Subject: RE: Please Approve the Permit for Segment 2B of the ELST

Thank you for contacting the City of Sammamish regarding the current Shoreline Substantial Development Permit Application for East Lake Sammamish Trail Segment 2B (SSDP2016-00415).

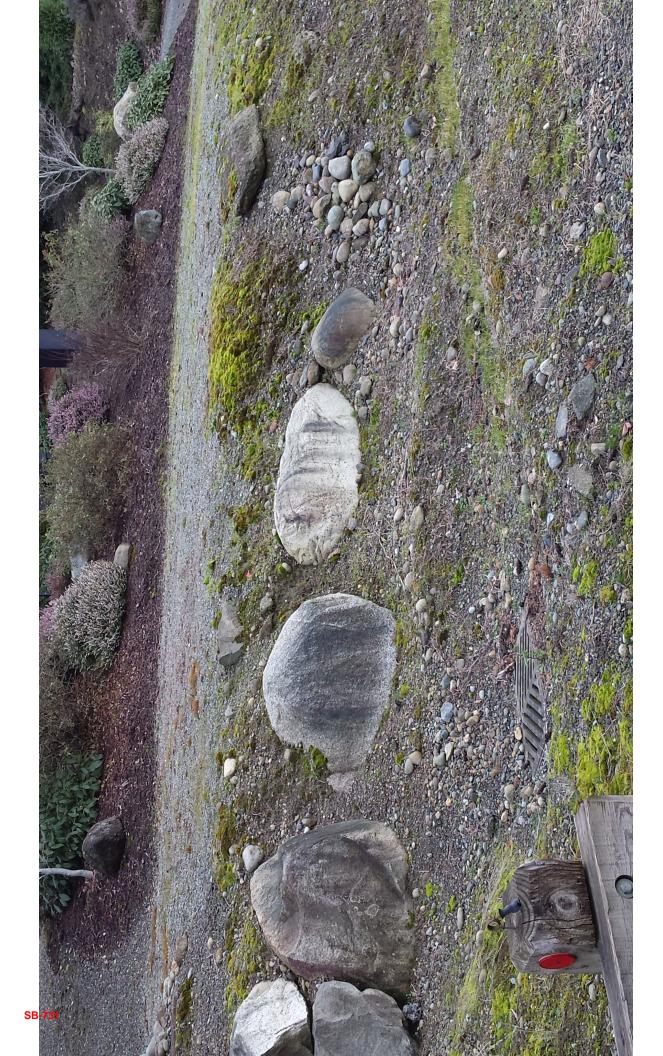
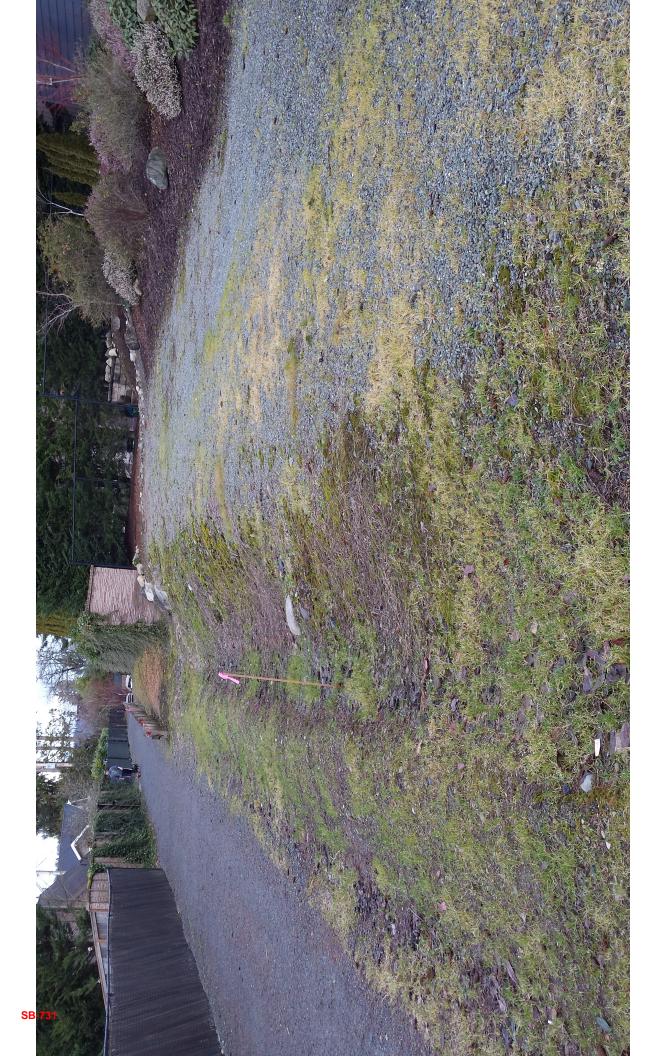
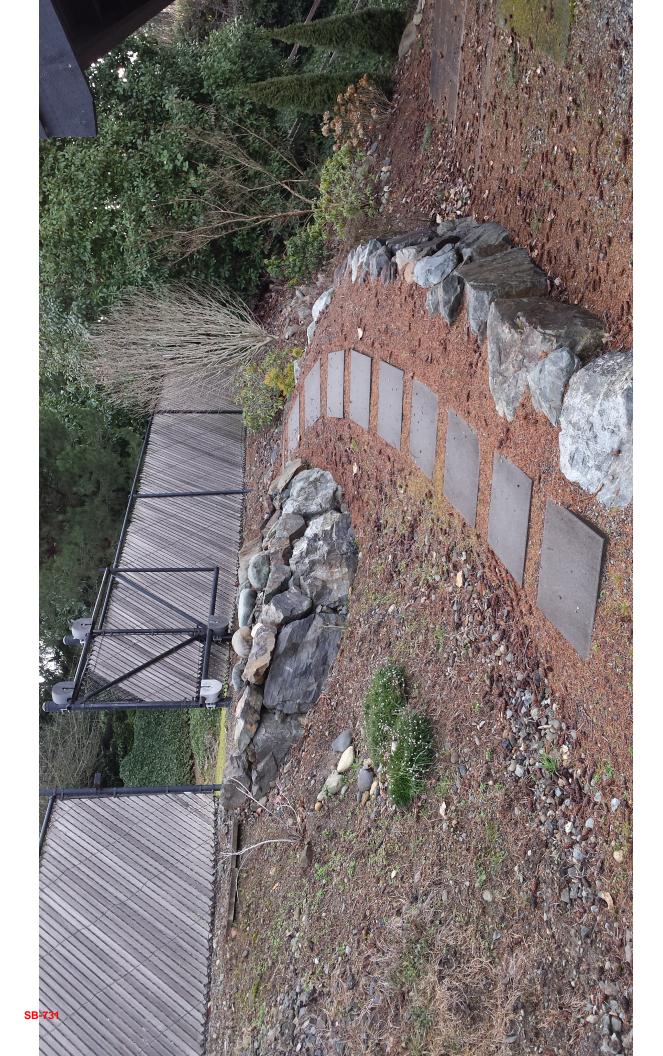
Our property, on the 60% review submittal, is located between station points 307 and 308. It is shown on Sheet 38 of 135 AL6 on the plan and profile. We have several comments, questions and observations for your consideration:

- 2. <u>Chain link fence on top of new wall</u>. How tall will the proposed chain link fence be? Will we be able to put wooden slats on the fence to maintain our privacy as we have with the current chain link fence? There is no provision on the plan for a sliding gate, similar to what is currently installed, to gain access to our property. We have a sliding gate that provides privacy and can be locked so strangers do not enter our property. Retaining a gate for privacy and security is mandatory.

- 3. Entry to cabin and recreational lot area. The proposed plan shows a landing with steps going down to a second landing. Our current entry from the gravel trail is a ramp, not a stairway. We designed and built a ramp when we constructed our home for a number of important reasons. We have friends and family who visit us and the steps will be a hazard. Many visitors carry items to our beach when they visit us, and steps are an impediment. We also have to clean the beach and bring garbage and yard waste up to the road for disposal. We use hand trucks, wheelbarrows and movable waste containers for this purpose. Steps are not a practical alternative and create a lot of extra work.

4. <u>Type 1 rest area</u>. There is a proposed type 1 rest area shown on the drawing. The plans do not show a drawing of such rest area. We would like to know what you are proposing. In this regard, we believe that this rest area is not needed and should be removed. The rest area is less that 1/2 mile from the 7-11 store, which is a major access point to the trail. We understand that restrooms and other amenities including parking will be in that area.

If the rest area cannot be eliminated, then it should be centered between B-Line Station 306+09.55 and 307+00 as it is a more appropriate area based on current utilities and drainage.

Although there is an open recreational lot in front of the proposed rest area, that will not be permanent. We designed and planned for the building of a new home that would be connected to the present cabin.

5. The CG (Cut and Grub) and C Line (cut line) area proposed near the Type 1 rest area and other CG areas. There is a very large area proposed for this work. When we built our home, we put our electrical, gas, water, sewer, telephone, and cable utilities for the cabin underground in this area. In addition, there is a large underground storm drainage pipe crossing the entire area.

During our construction process, great care was taken in locating and installing all utilities and drainage components. The County will have to exercise extreme care and precaution within all CG areas to avoid damage to all these items.

6. <u>East side of trail drainage</u>. There is an existing large ditch running on the eastside of the trail that requires some type of drainage work for runoff along the trail. We put in an extra catch basin for this purpose near station point 308. We have no information regarding the plans for drainage in this area. We need information and clarification how this will be protected and preserved.
